i3V2.1 Feature list , REV.A 14th April 2016

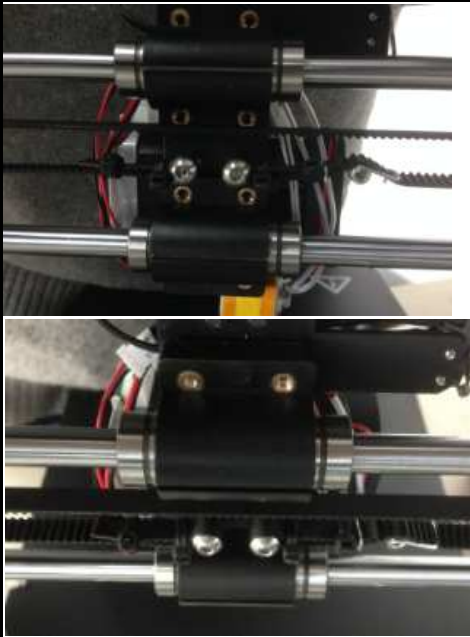
| I3V2 issue | I3V2.1 improvement | Pic |
|---|--|--|
| <p>I3V2 Z axis end stop has narrow contact with the gantry. Any deformation of frame would cause the mis-contact.</p> | <p>The new design place the end stop vertical to the gantry. So 100% touching ensured. And no protection tape is required.</p> |  |
